ARCHITECTURAL ACCESS BOARD - HEARING PACKET

Name **New England Sports Center**
Address **121 Donald Lynch Blvd.**
City **Marlborough, MA 01752**

Site Visit Report

RE: New England Sports Center, 121 Donald Lynch Blvd, Marlborough (C24-002)

#18

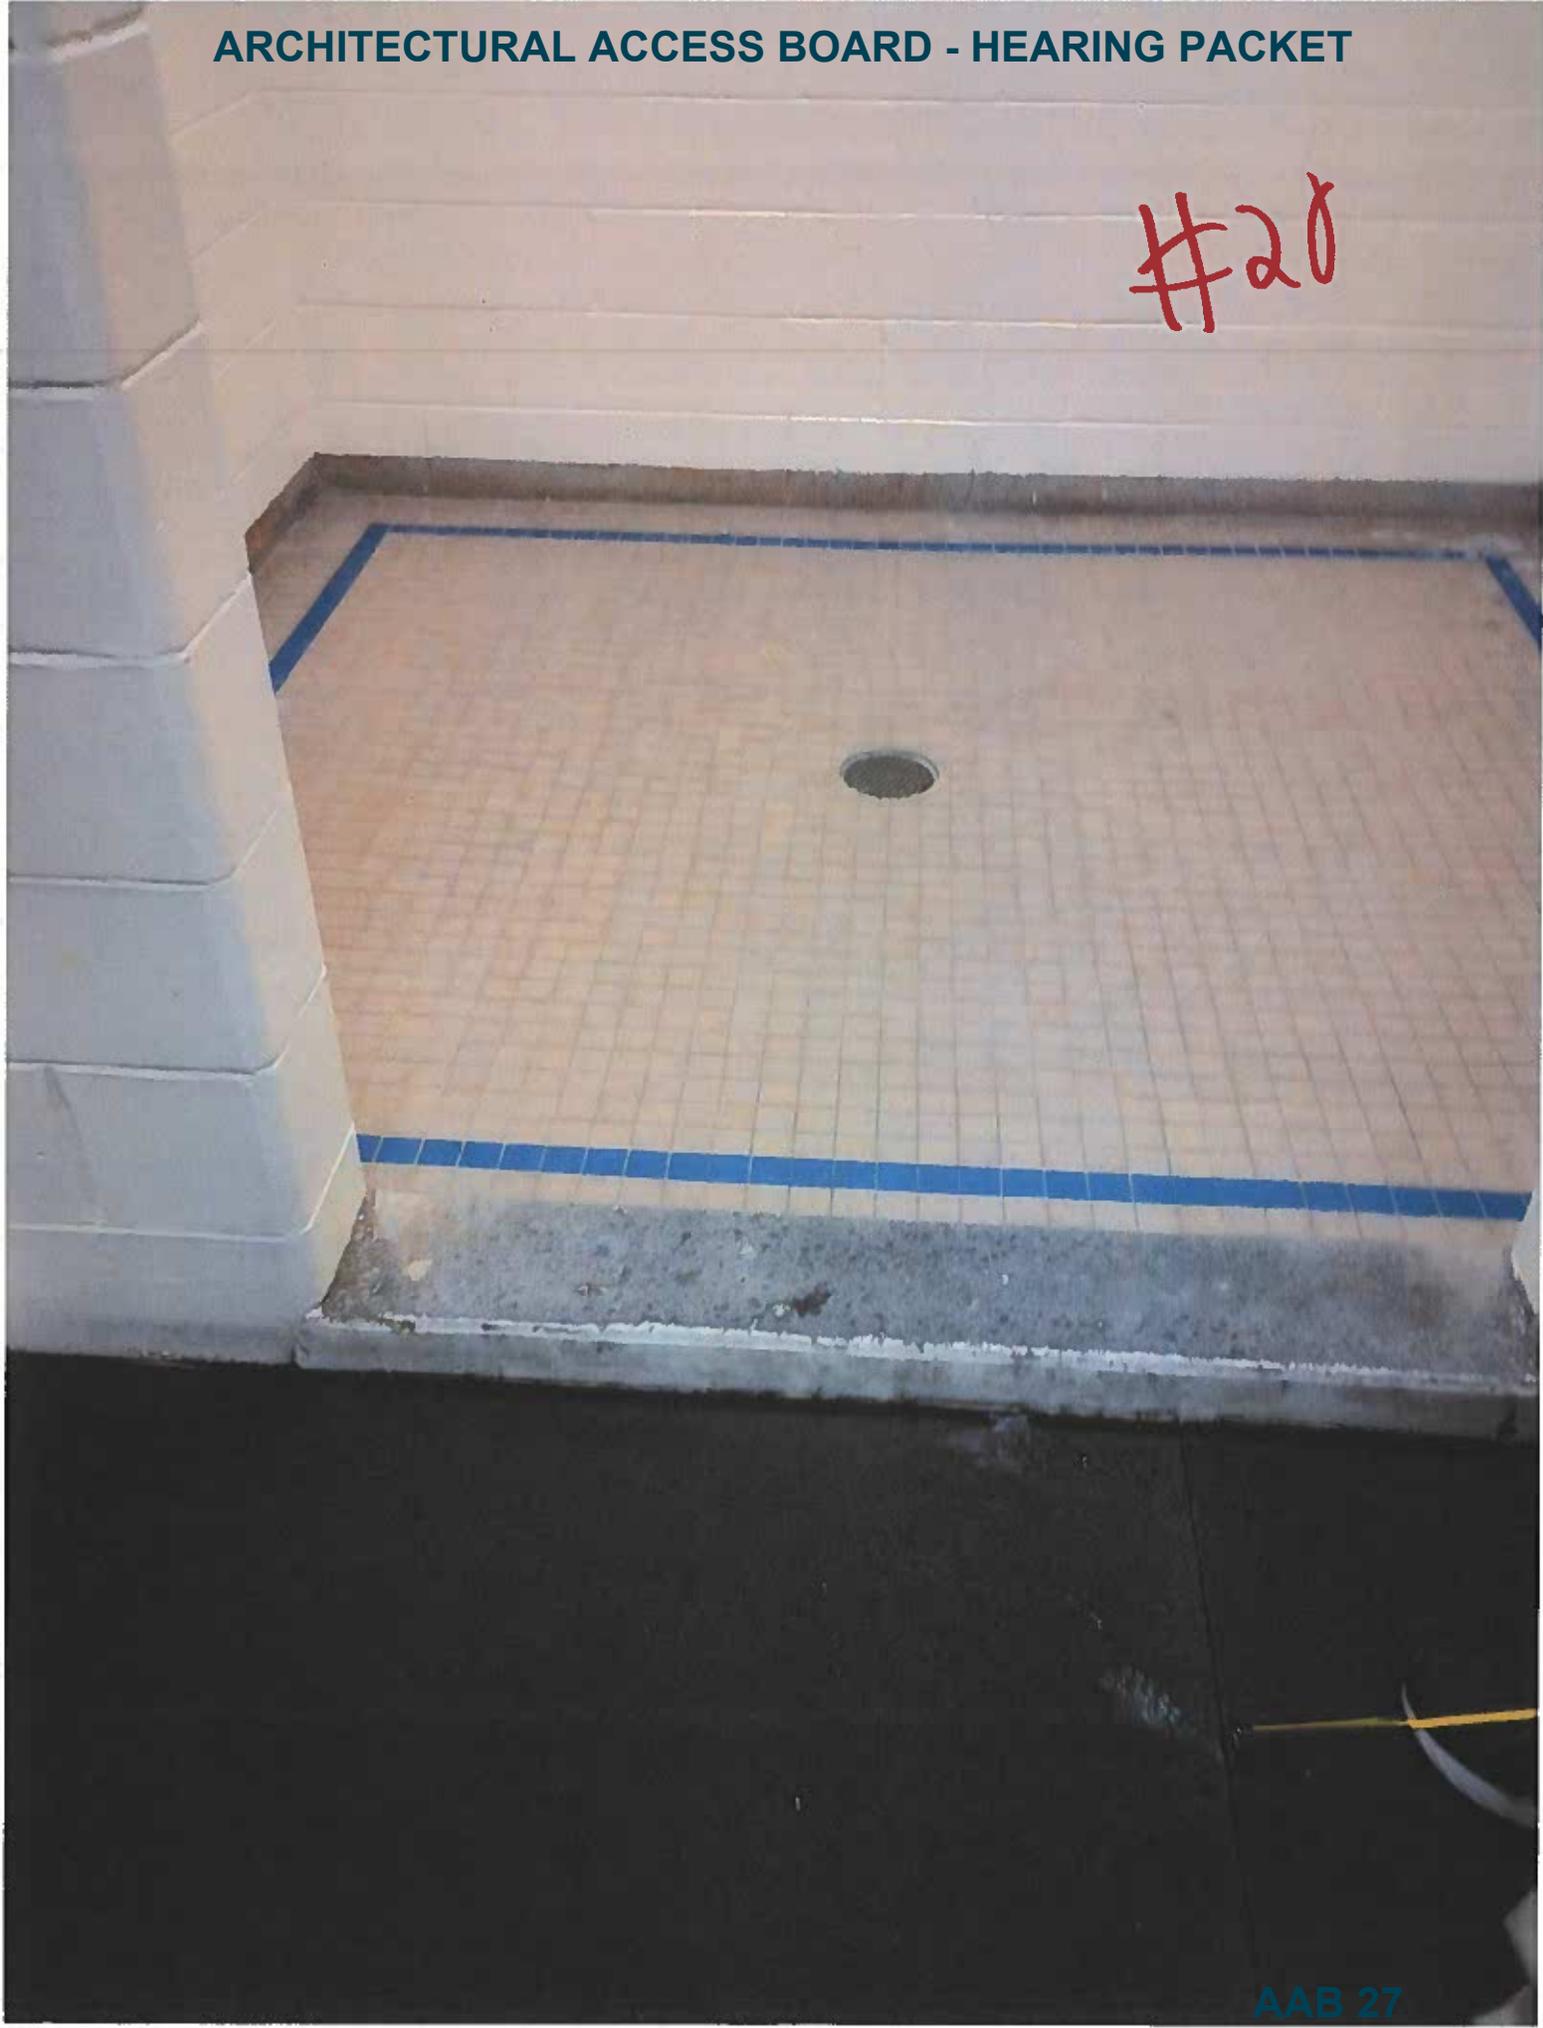
The first-floor men's bathroom was then inspected. The door was measured as having an opening force of 18 lbs. Mirrors and knee clearances at sink were measured as compliant. Centerline of toilet was measured at 17 inches, one inch short of the requirement under 30.7.2 (see **photo #17**). It was also noted that the door to this stall was missing the 18-inch clearance from the pull side latch, as well as missing a handle from the pull-side of door (see **photo #18**). It was also noted that a small trash can was obstructing the turning radius within the accessible stall (see **photo #19**).

#22

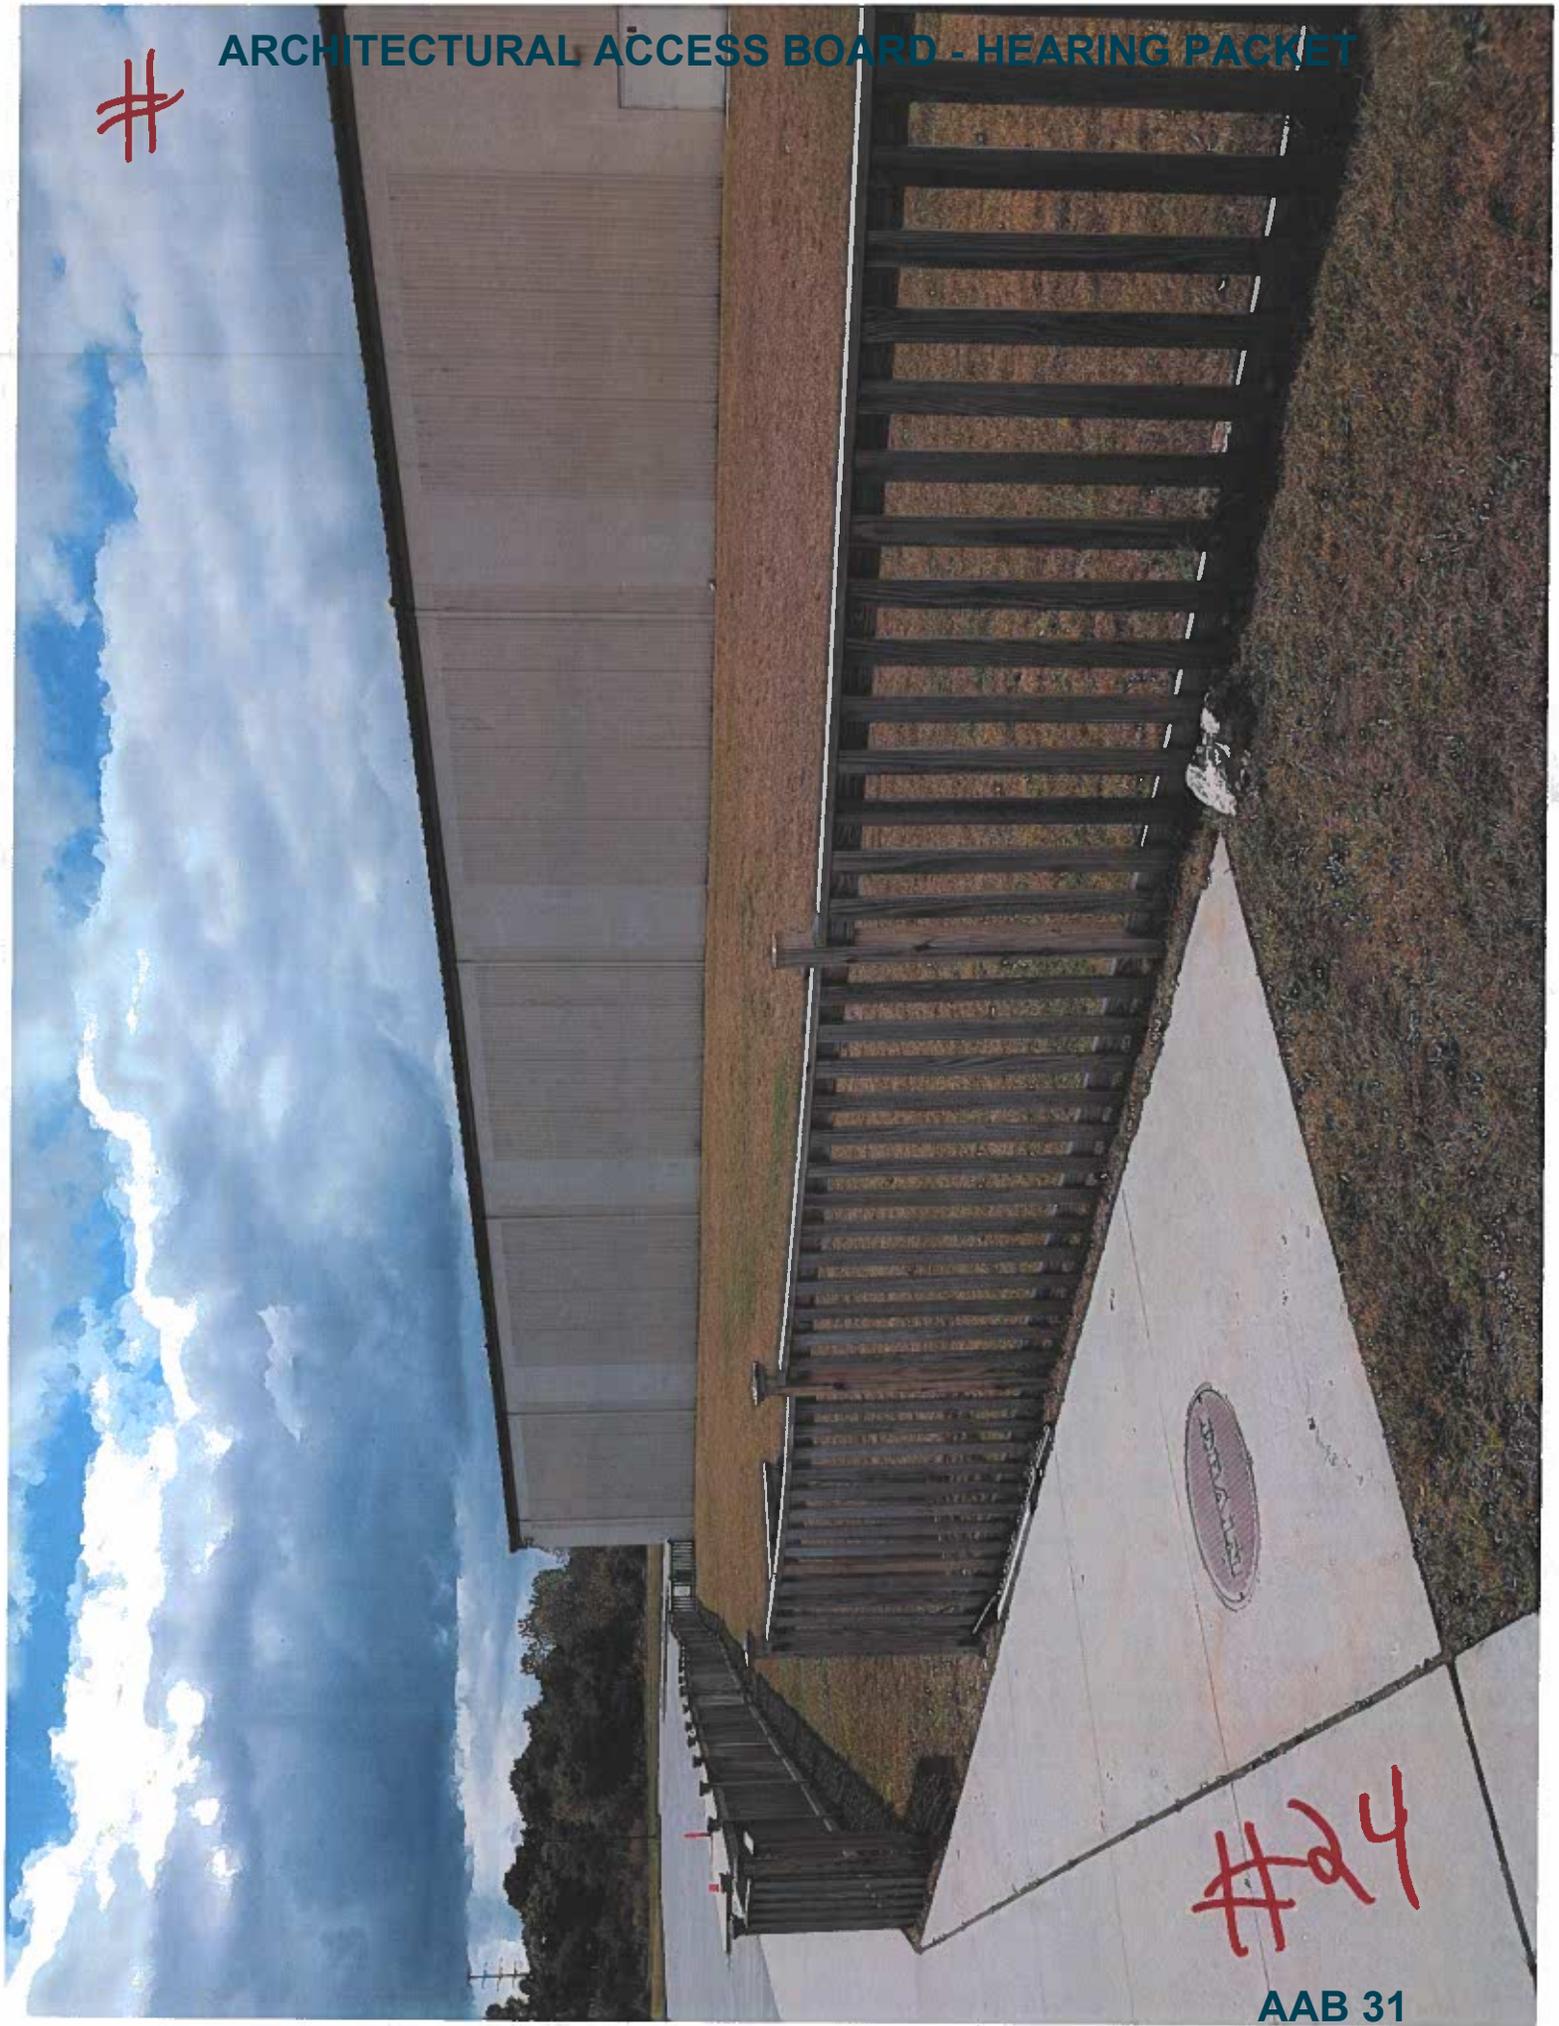
We then entered the pro shop. The transaction counter was measured as having a height of 38 inches, two inches higher than the maximum allowable under 521 CMR 7.2.1c (see photo #22). Several retail aisles were also measured as having a clear width of less than the minimum 36 inches (see photo #23).

**New England Sports Center
Elliptical Staircase Photographs**

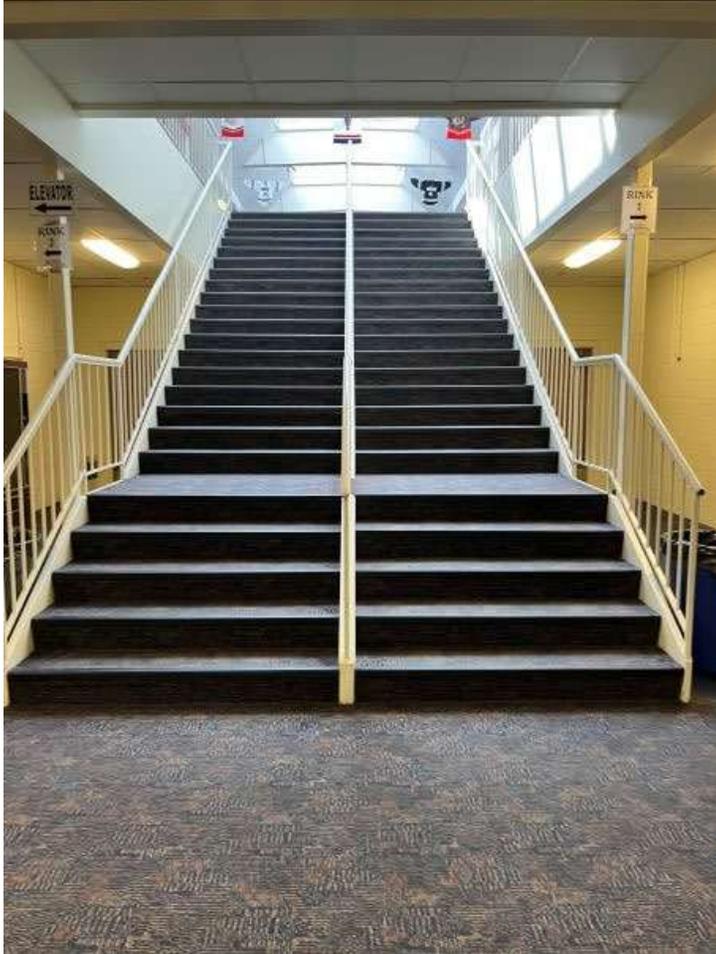
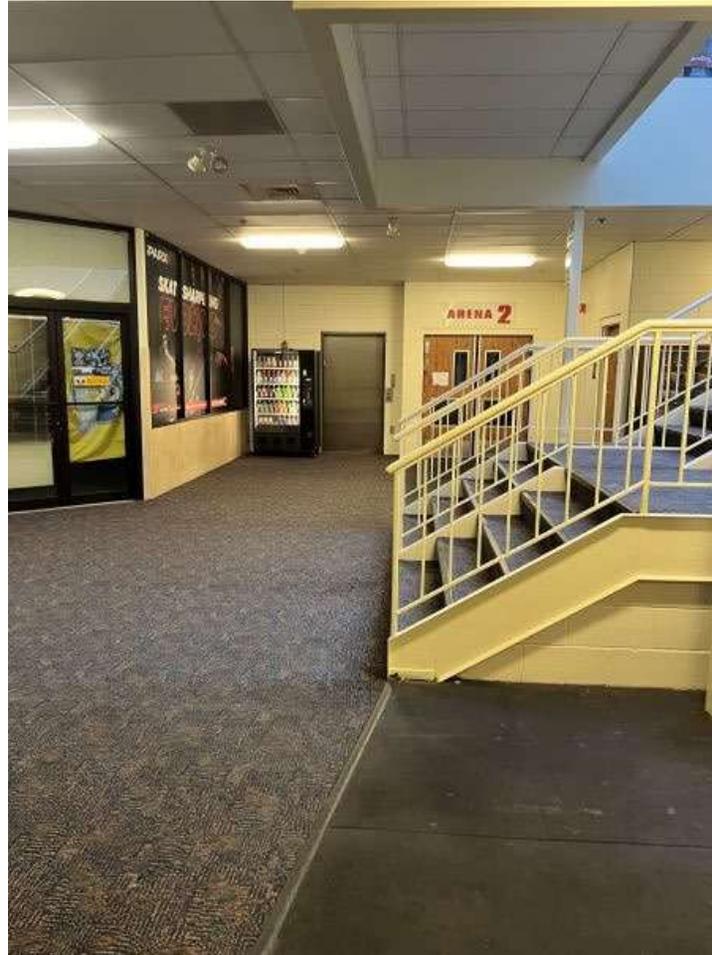
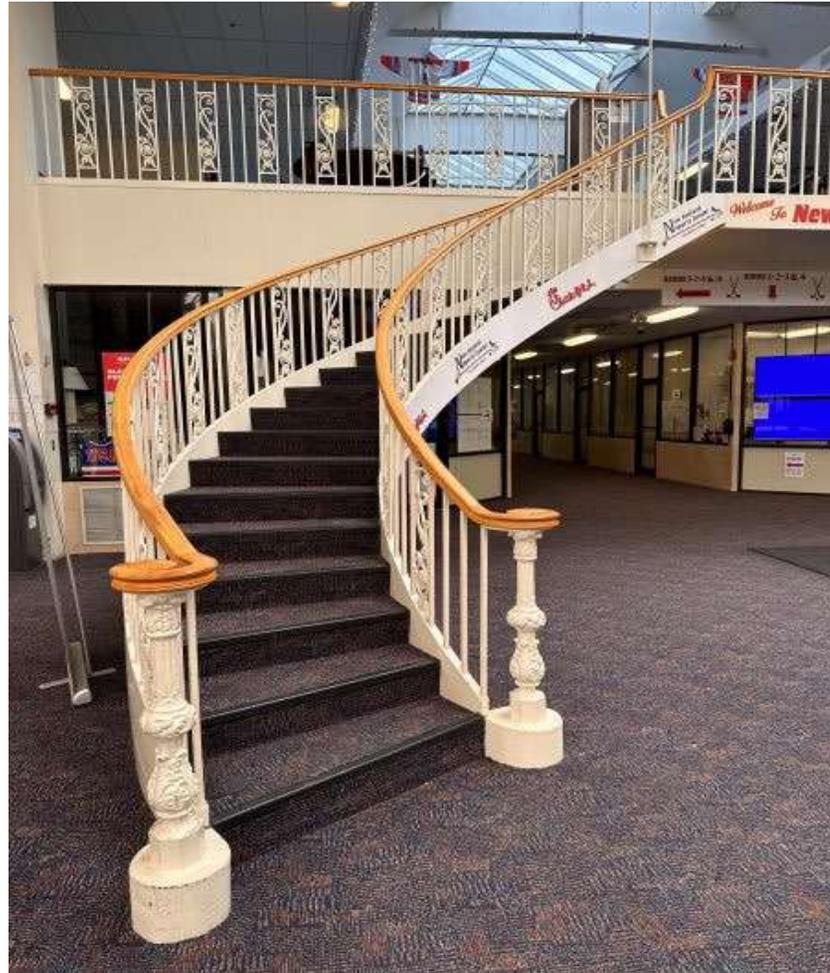
He identified one non-compliance that would be very difficult and costly to replace with a compliant one, the elliptical stairway in the building atrium. and didn't consider its removal and replacement to be of any substantial benefit to persons with disabilities. His recommendation was to submit a variance request for this one non-compliance given that the elliptical stairway was considered safe and easily navigated by persons with disabilities that could use stairways, and that many compliant means of access to the mezzanine were available, the two most notable means being the main stairway and elevator.

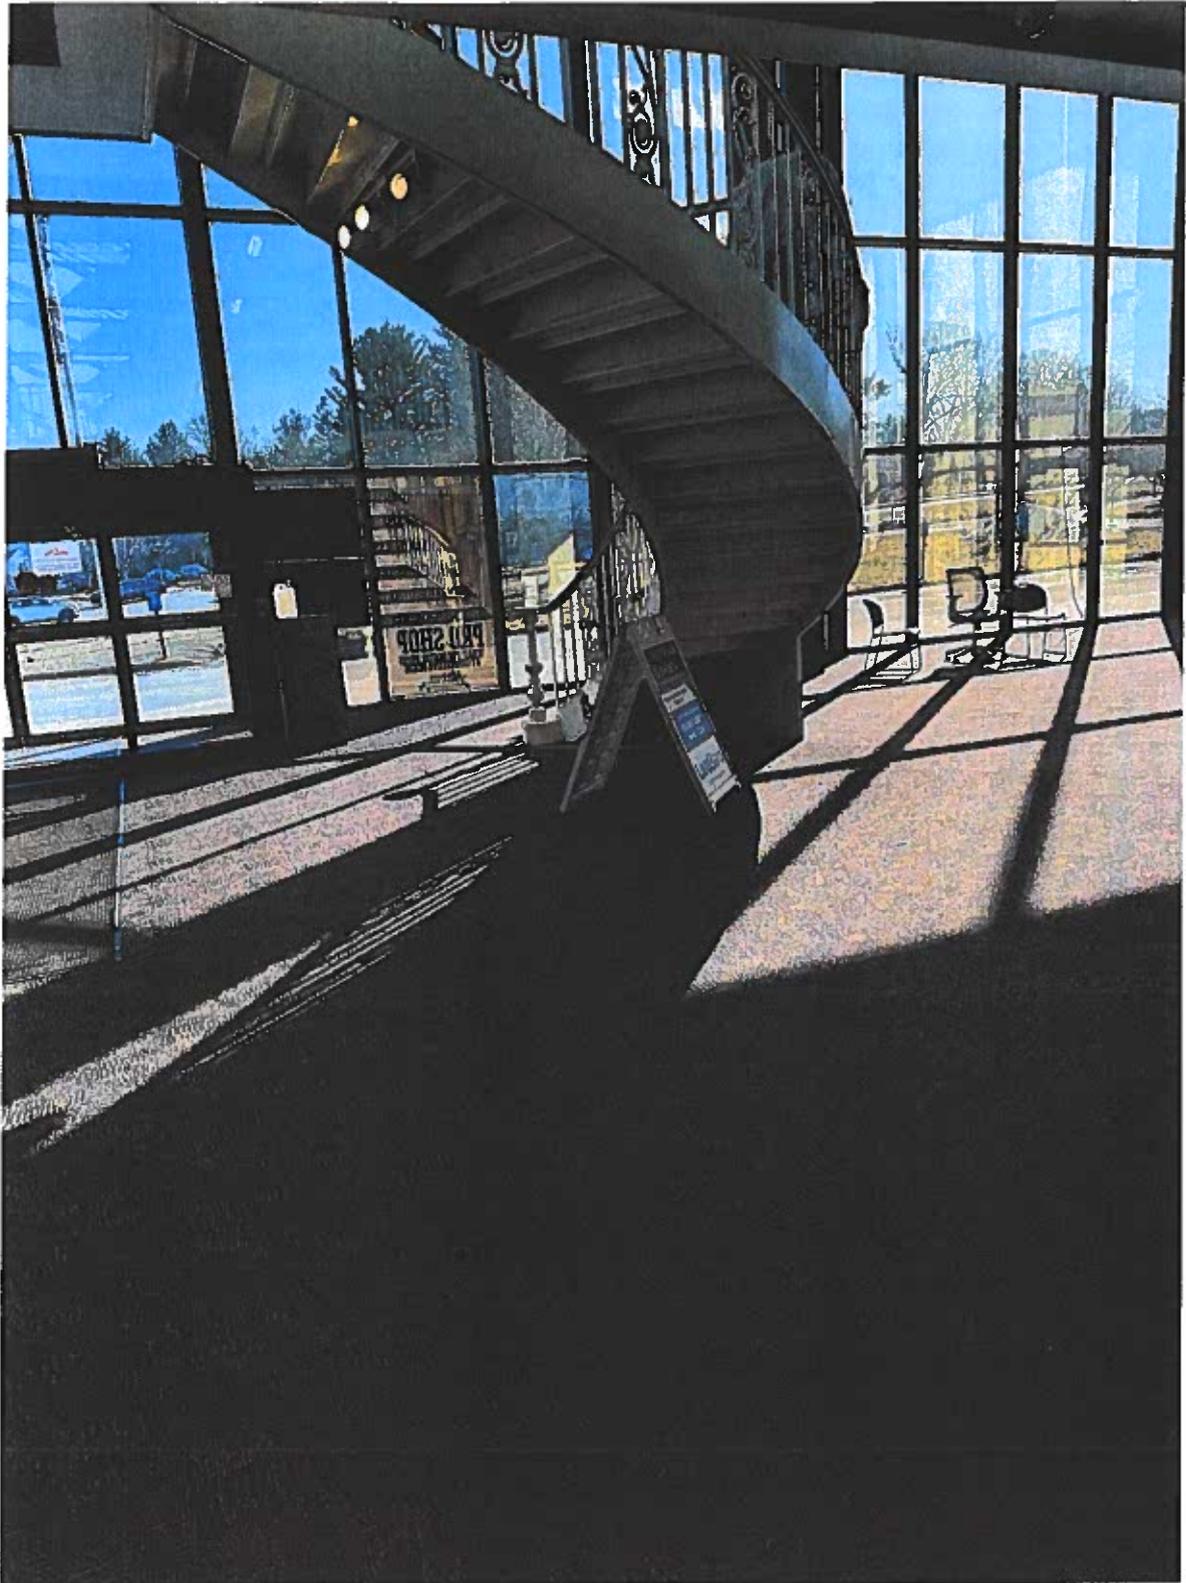
picnic AREA provides no accessible
Route do to surface.
20.8 / 29.1

20.7 Stairs obstruct Route.

27.2 Stair Risers treads are pie
Shaped do not provide uniform tread.
